ADDENDUM NO. 1

Job No. F70C616E
SAND ISLAND STATE RECREATION AREA
SEWER SYSTEM IMPROVEMENTS
PHASE 2: PUMP STATION 3 RELOCATION & FM 3 REPLACEMENT
Honolulu, Oahu, Hawaii

02/22/21

| APPROVED: | DRAWING NO. C010 |

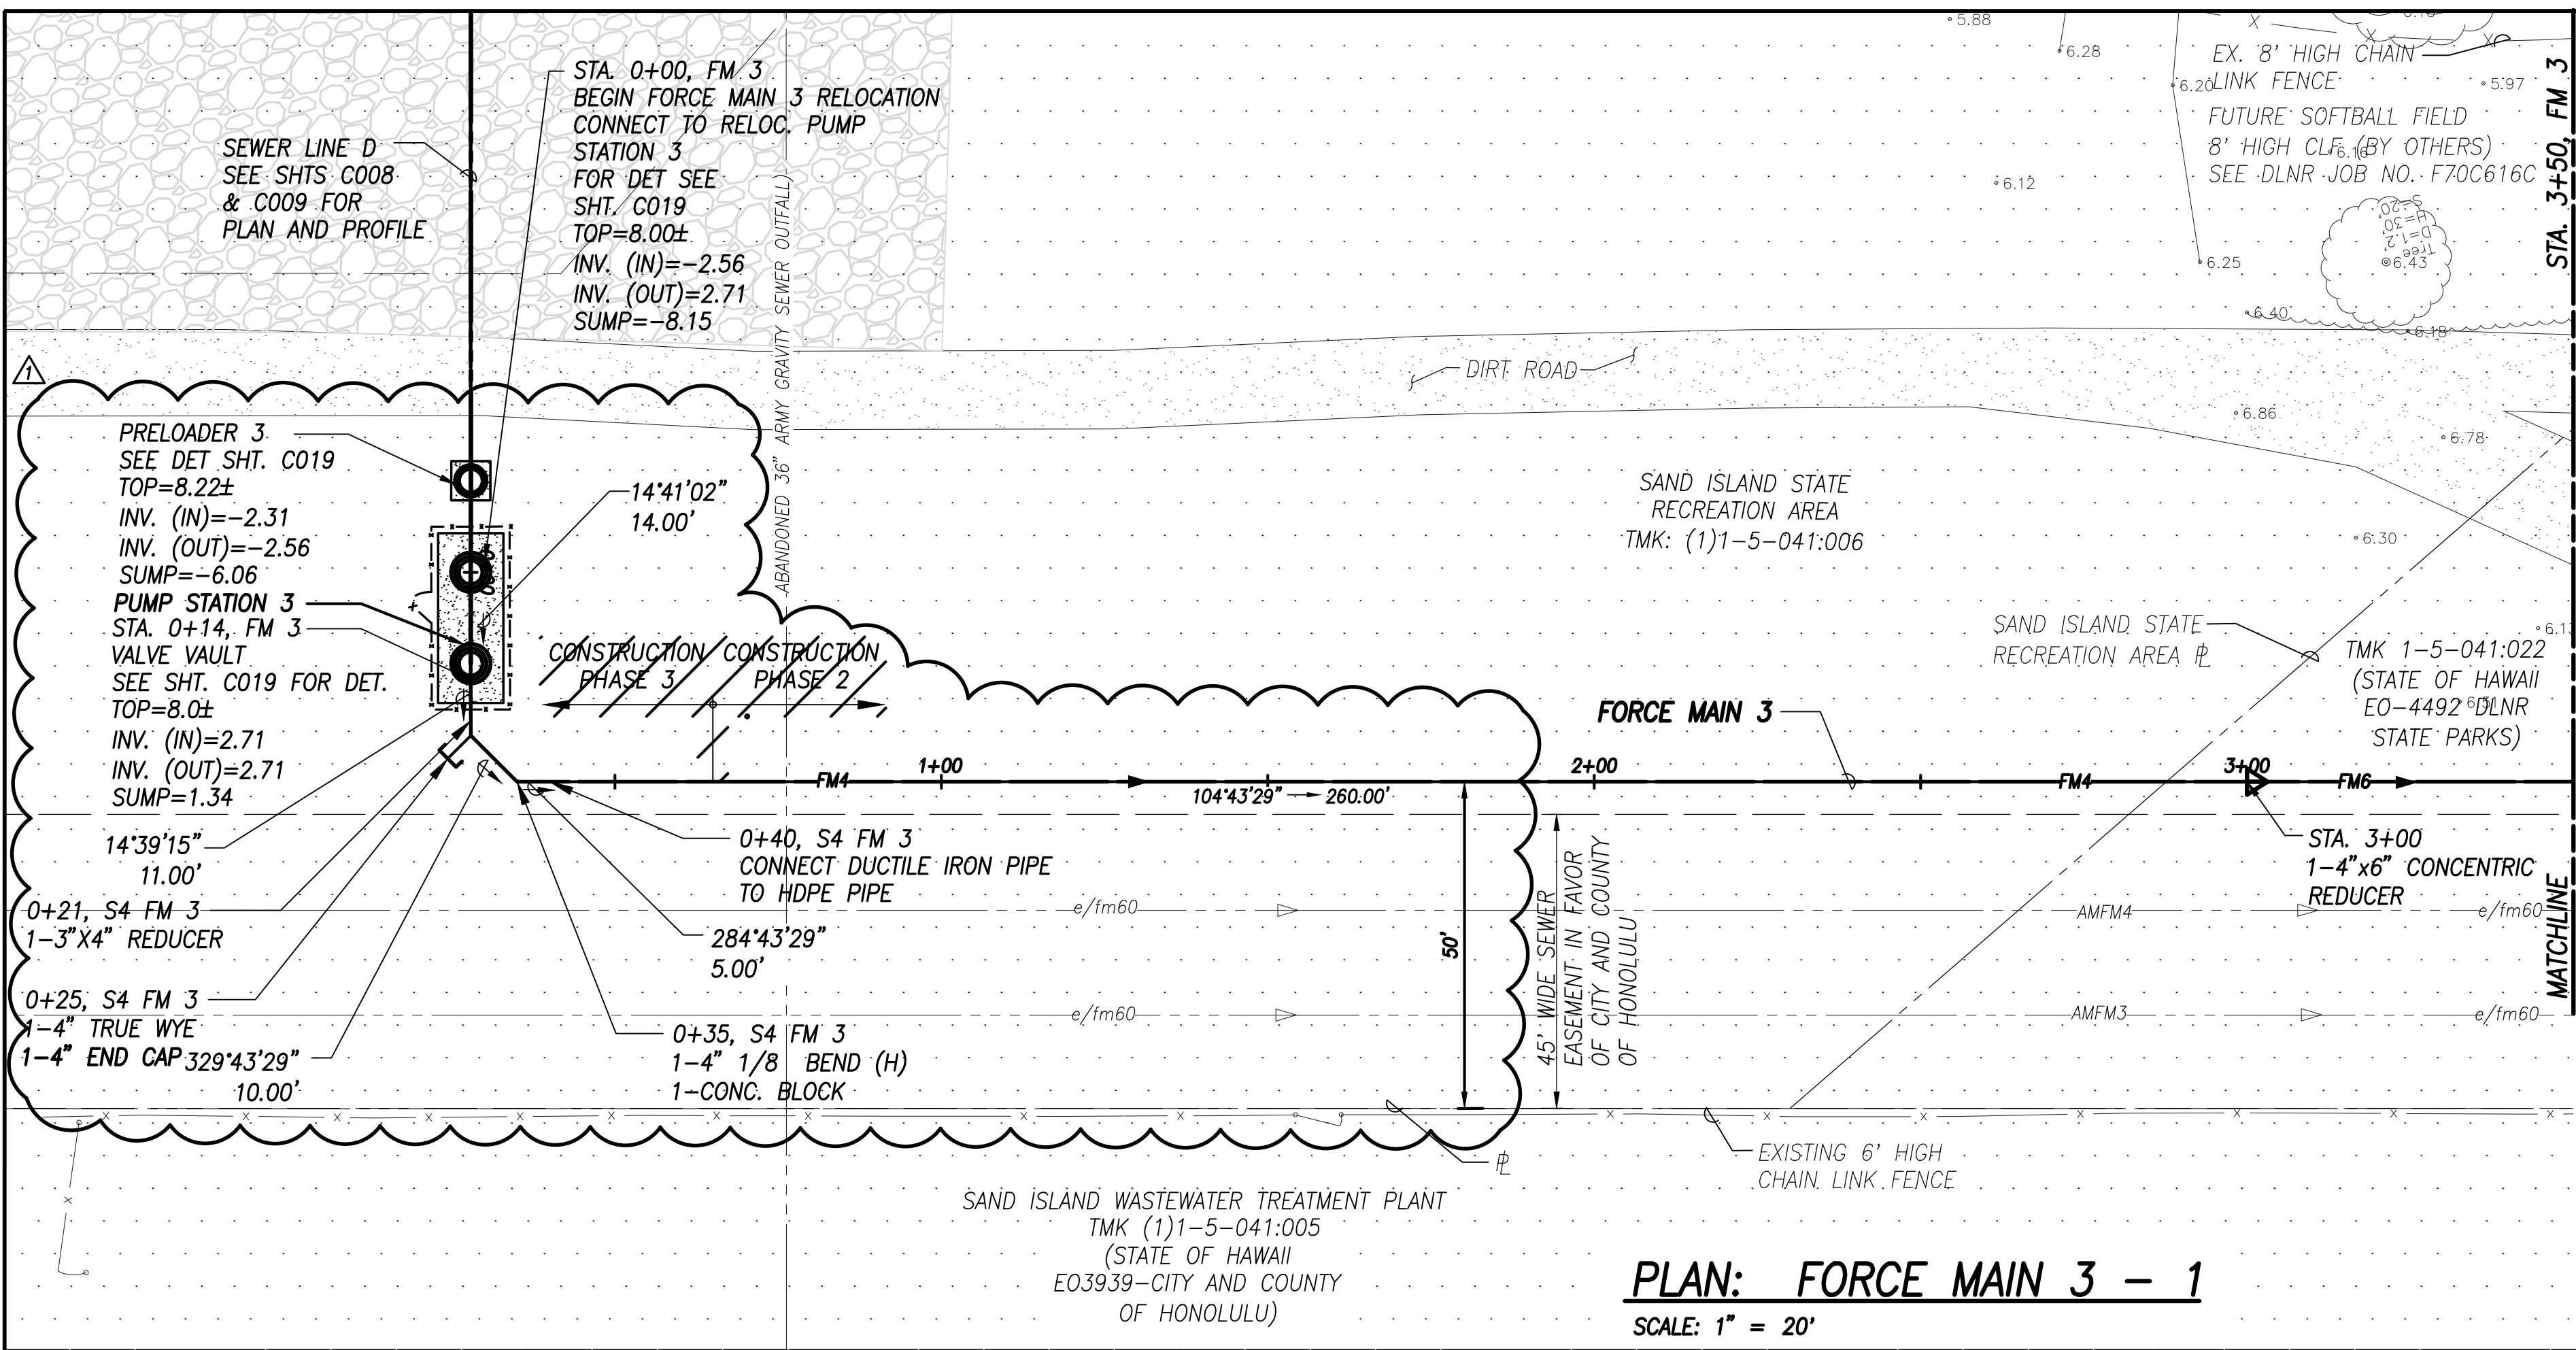
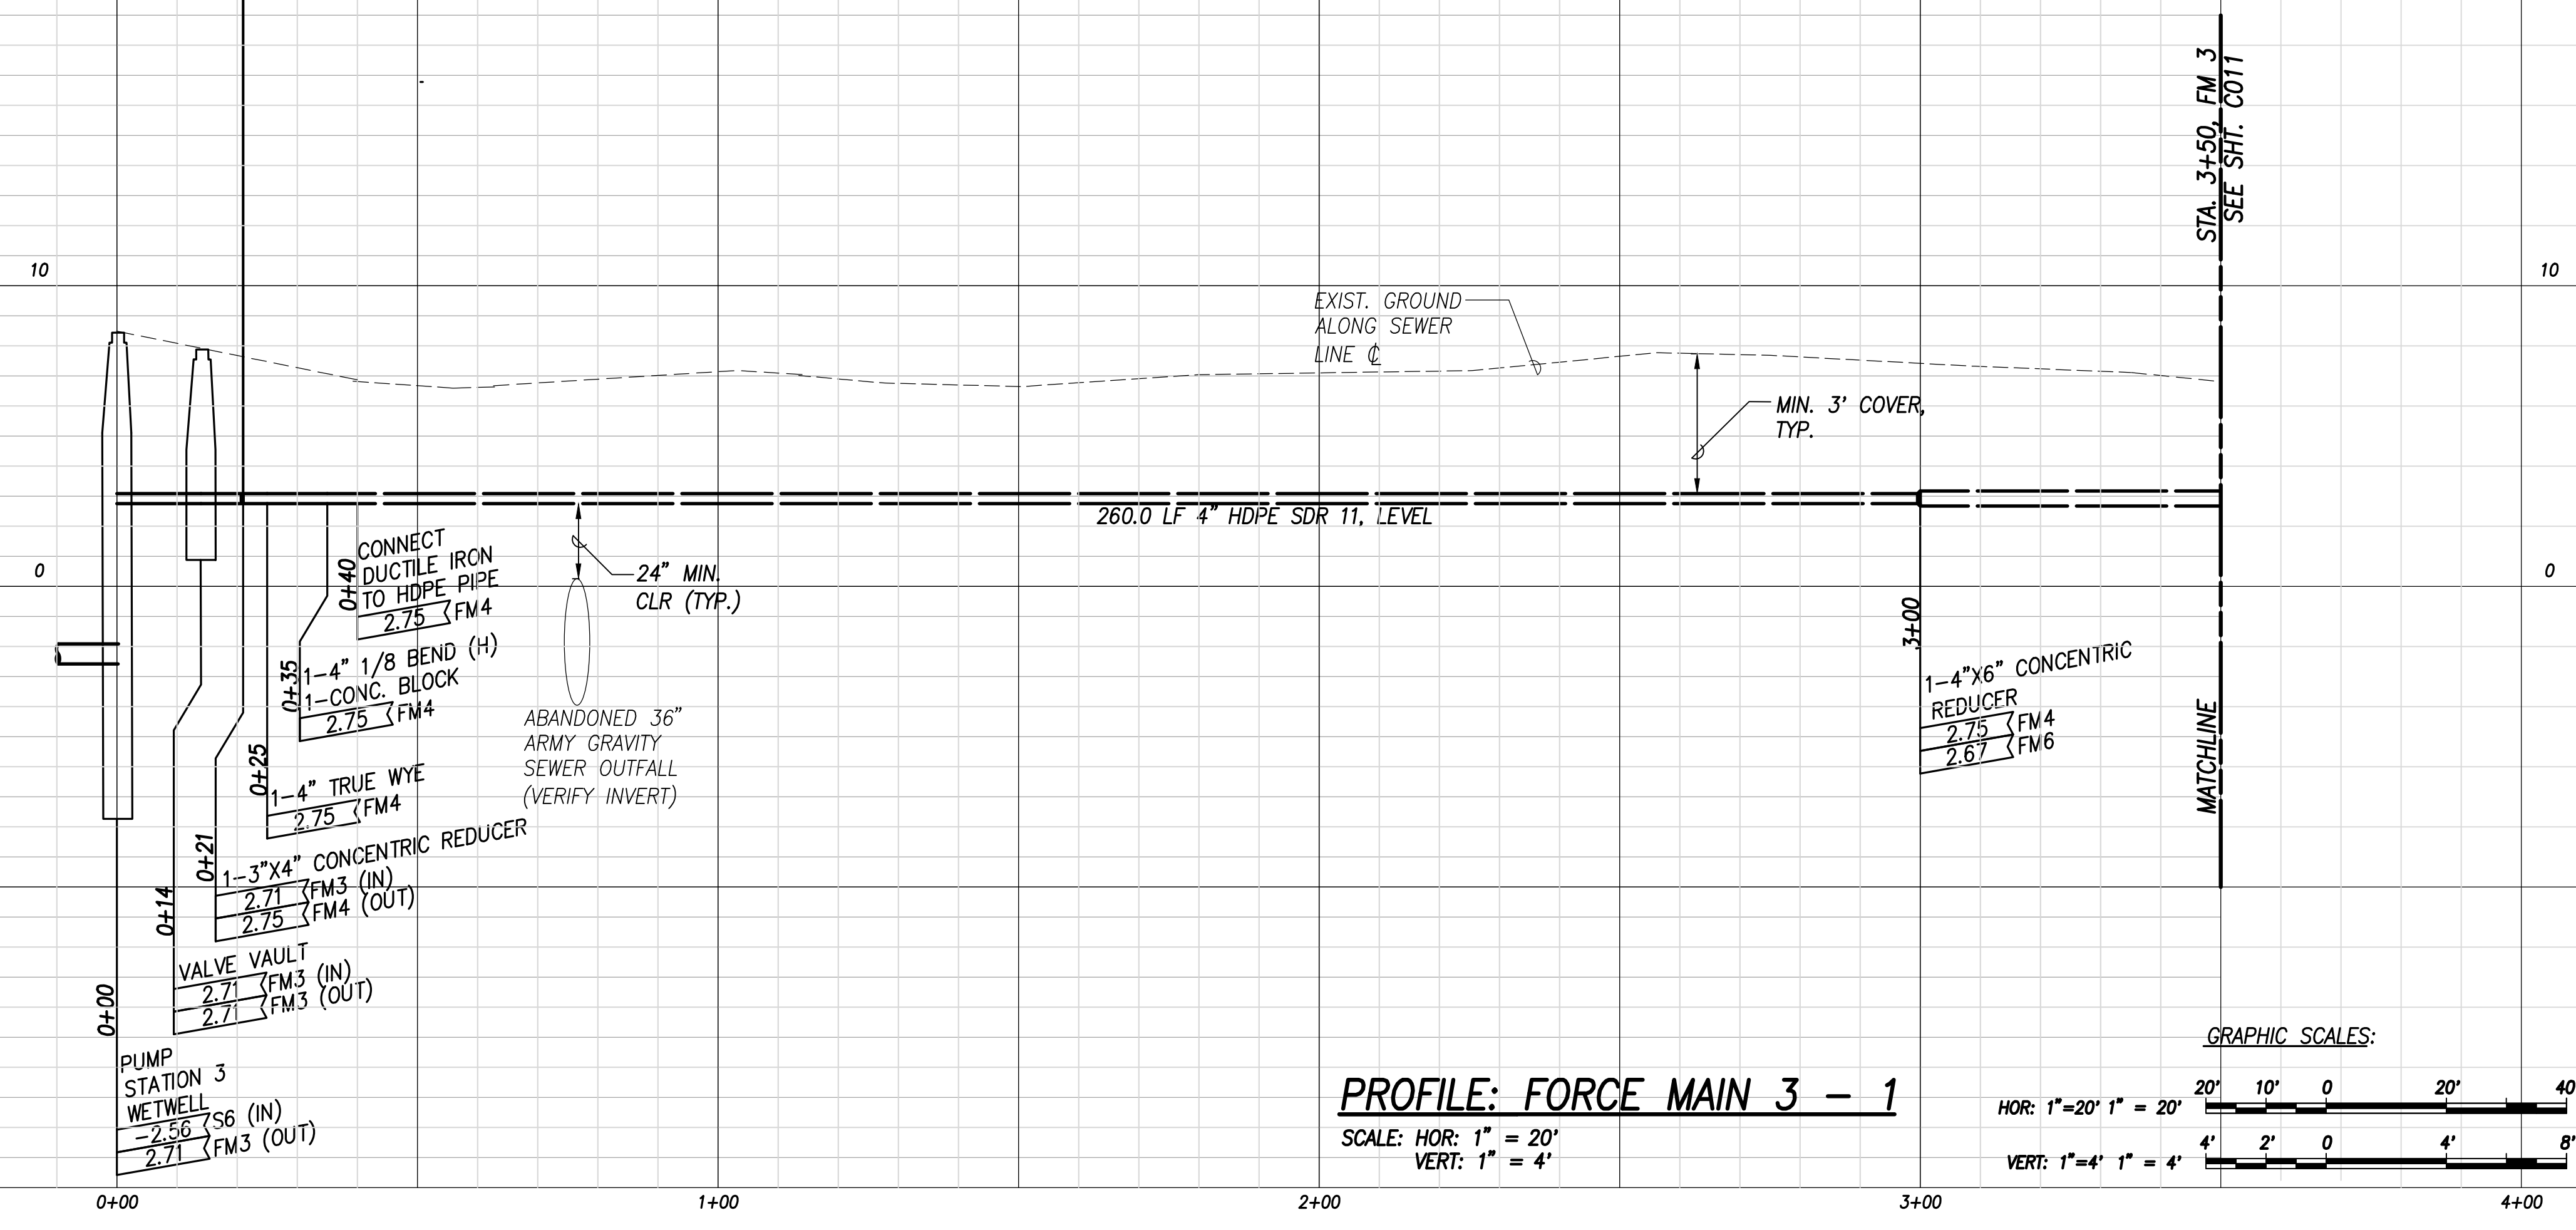
5. Sheet C010, "Force Main 3 Plan and Profile – 1."
 - a. Added callout for "Pump Station 3"
 - b. Added "1-4" end cap" to true wye at Sta. 0+25.
 - c. Removed callout for Construction Phase 3 and Construction Phase 2.
 - d. Added callout to show new Force Main 3 is 50 ft from property line.
 - e. Removed Note #1, "Contractor to provide continuous sewer service."
 - f. Removed Note #4, "If new force main alignment deviates from the exiting force main alignment, the contractor shall CLSM fill and abandon in place."
 - g. Added Note #5, "Use of dirt road shall be shared by various contractors. Contractor shall coordinate with concurrent and future projects. See sheet C005A."

42. Please confirm that station 0+00 to 0+40 is 4" HDPE SDR11 in lieu of DIP as noted on sheet C010 at station 0+40. If not please provide a bid item for DIP.

Answer: SFM3 from Sta. 0+00 to 0+40 is DIP, see revised proposal schedule in this addendum.
